## Product Change Notice (PCN)

Your customer number:  
Your contact person:  
Tel.: +49 8153 9999 699  
E-mail: [PDN@raylase.de](mailto:PDN@raylase.de)  
Date of publication: 28/03/2025  
PCN ID/version: 202502-01

Due to application-specific requirements from the electromobility market, water-bearing, nickel-plated brass plug-in connections (fittings) for water cooling must be avoided. We are therefore converting all water connections for the product lines and components listed below to stainless steel.  
This will not change or impair the previous functionality.

### Graphic overview:

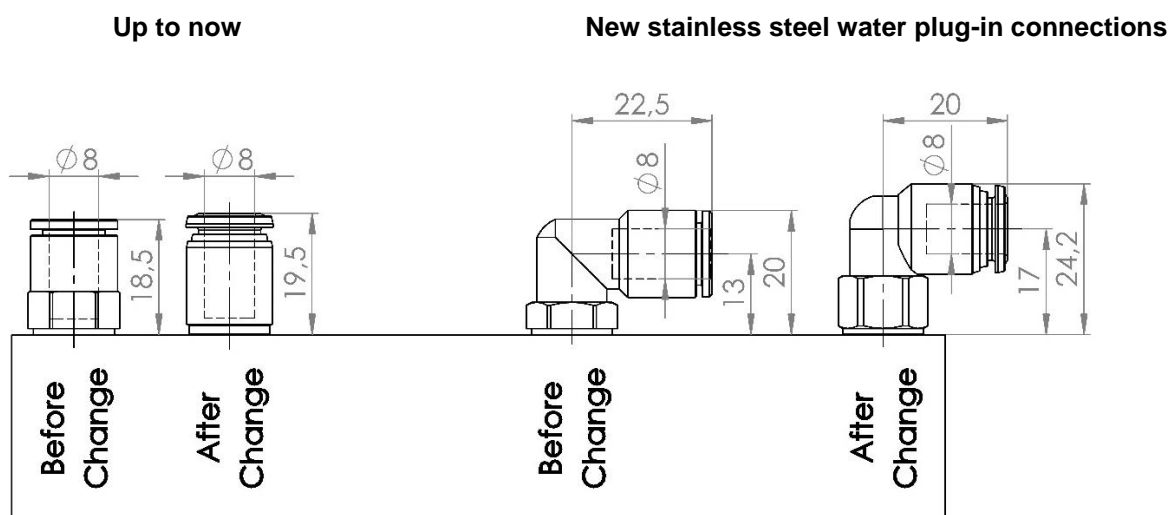
The dimensions of the new stainless steel water plug-in connections differ only slightly from the previous nickel-plated brass plug-in connections (→ see graphic overview).

Due to their position on the master block of the deflection units and on the collimators, it cannot be assumed that this will cause collisions in existing machine generations.
